# UNITED STATES PATENT AND TRADEMARK OFFICE

## Office Action Summary

10/635,956

## DETAILED ACTION

[54] **HEAT-RECOVERING-THRUST-TURBINE  
 HAVING ROTATIONAL FLOW PATH**

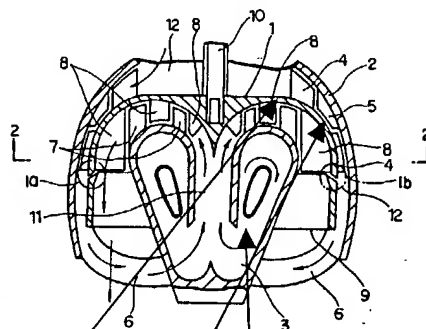
7. Claims 7-12, 16 are rejected under 35 U.S.C. 103(a) as being unpatentable over Lee et al (5,241,815) in view of any of Box et al (6,374,592), Reichard et al (4,286,431) and Stram, Jr. et al (3,124,933). Lee et al teach an air breathing gas turbine engine comprising: a combustion chamber section 3; a turbine section 8 surrounding the combustion chamber section 3 so that at least part of the combustion chamber section is nested within the turbine section; a compressor section 4 surrounding the turbine section so that at least part of the turbine section is nested within the compressor section. Lee et al do not teach a starter cartridge connected to the combustion chamber section for feeding gases into the combustion chamber section, wherein the starter cartridge has a base shaped to define a toroidal region of the combustion chamber section. Box et al teach a starter cartridge 50, 52 of solid propellant in the combustor for starting the turbine. Reichard et al teach starter cartridges A, B, and C (threaded/positioned in an opening) inside the combustor for starting. Stram, Jr. et al teach a starter cartridge 60 (Fig. 4) threaded/positioned in an opening in the combustor for starting the turbine. Each

of the starter cartridges when inserted into the combustor defines a toroidal region inside the combustion chamber. It would have been obvious to one of ordinary skill, to employ a starter cartridge in the combustor as a well known means for starting/igniting the combustion and/or turbine operation. Note that there is already a recirculation zone defined within the combustor of Lee et al and it would have been within the ordinary skill in the art to place or thread the starter cartridge in the recirculation zone, as an obvious matter of finding the workable locations in the art. The rotor of Lee has a first and second compressor stage and first and second turbine stage, hence because the rotor is integrally

formed in stages it can also be considered a first and second rotor.

First rotor    second rotor    recirculation zone

Furthermore, the first and second rotor has an exo-skeletal arrangement with an outer support ring retaining blades of the first and second turbine portion. The first turbine portion blades have a free inner edge.
